## Modification of the powerplant – ignition unit to Ducati 432372501 ignition electronic boxes

Picture 1 (both versions of the filter are possible)

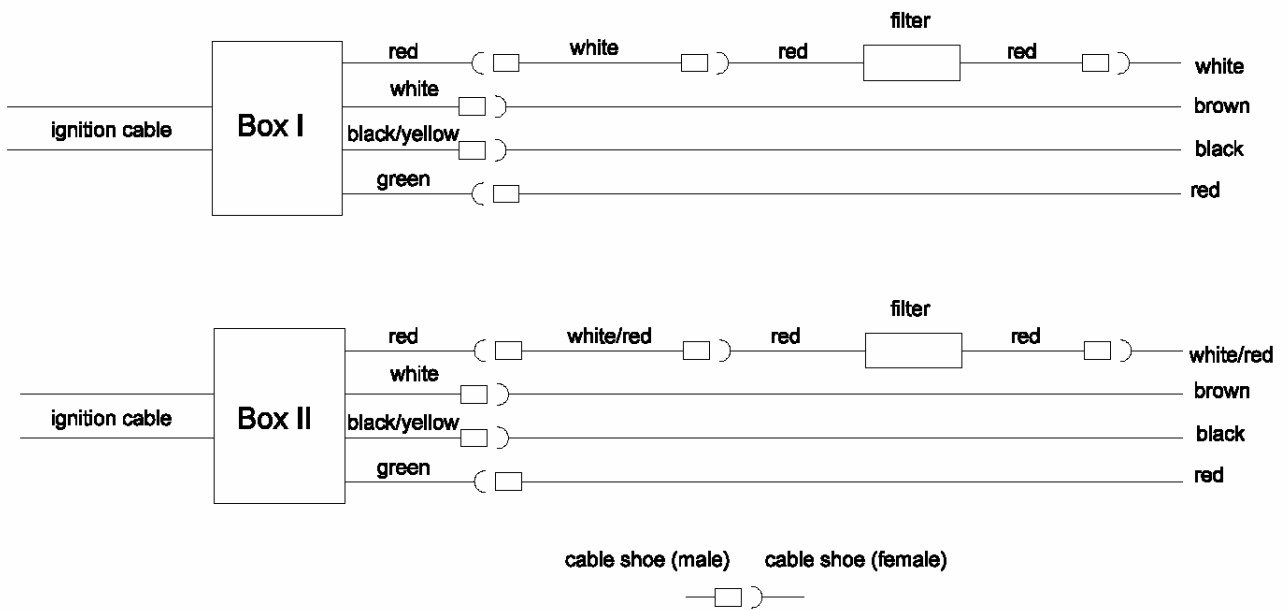
3. Plug an ignition box filter (pict. 1) to each of the two cable shoes. Slip heat shrink tubing over the connections and shrink the tubing. Take care of the correct mounting direction. (see pict.2).

Picture 4

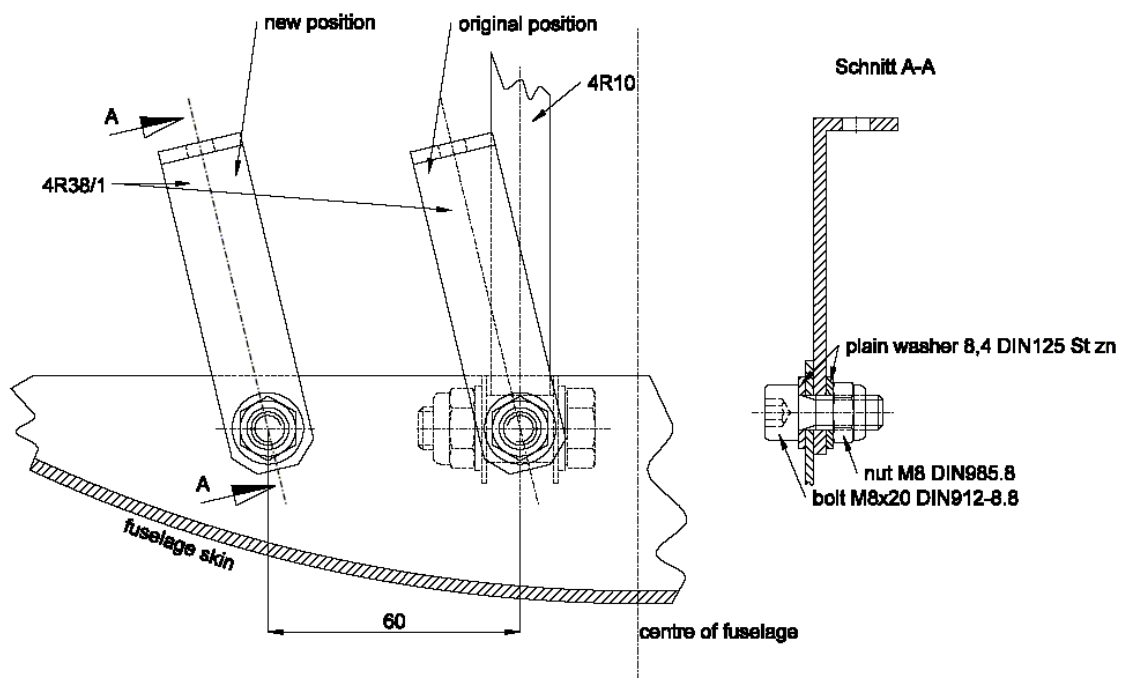
9. Cover the cable harness completely with heat shrink tubing.
10. The cable harness has to be fixed. The cable harness should not be able to vibrate or rub. Fix the cable harness according to pic3,4 and 5 and drawing 4M77. The ty-raps have to be tightened by hand as tight as possible.

Sketch 1

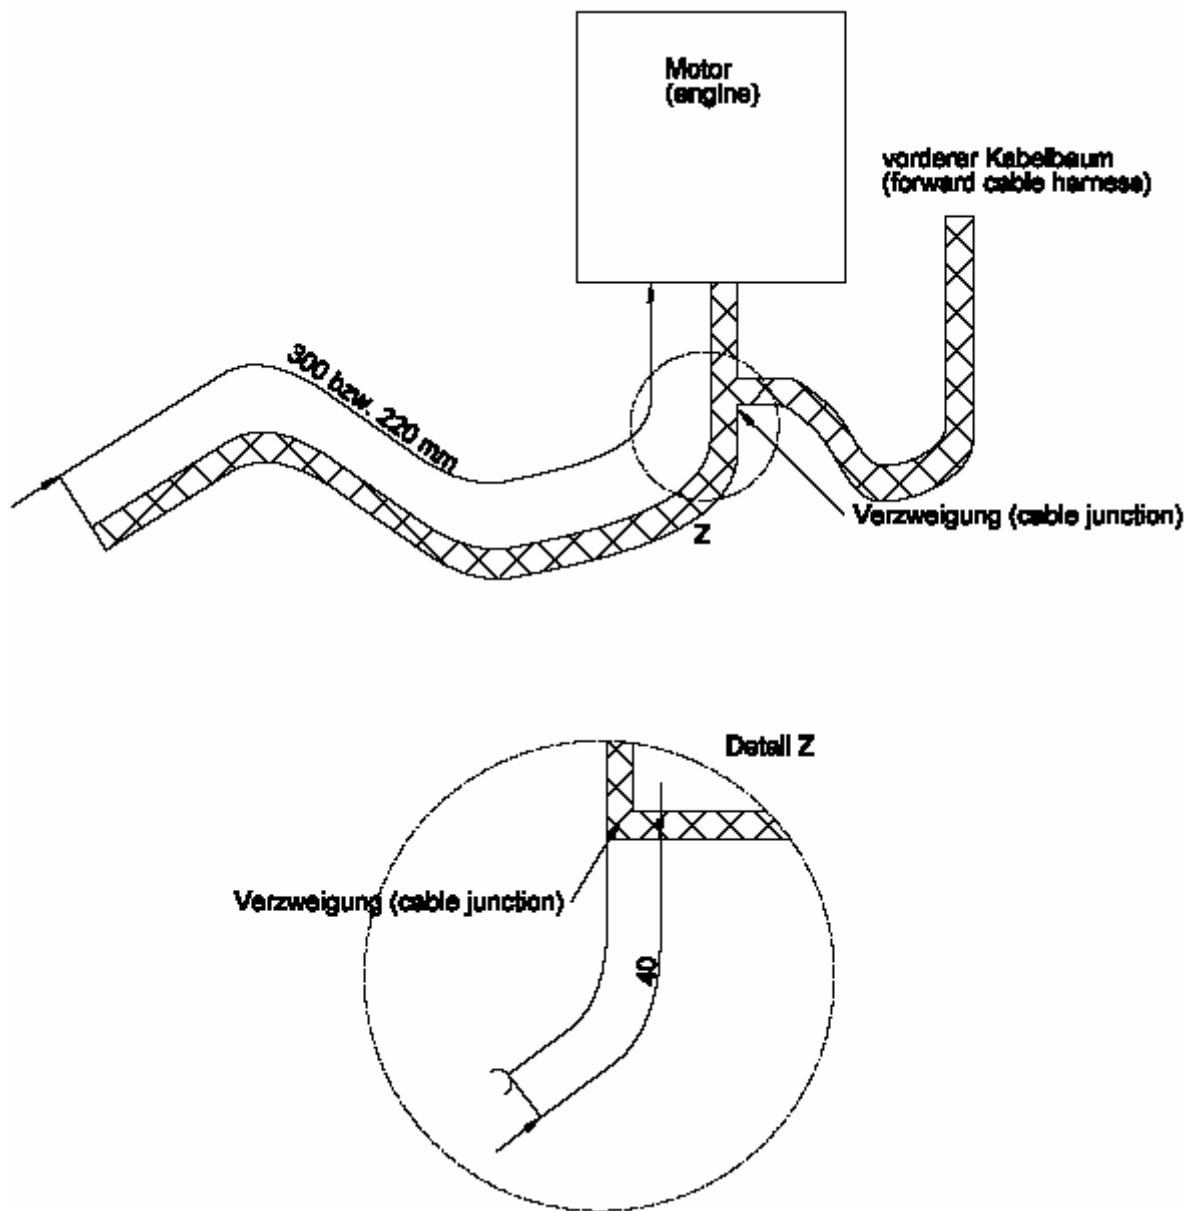
11. Move the Bowden cable mounting 4R38/1 60 mm from the original position to the position (see sketch 1). This must be done even when Ducati boxes have already been installed.
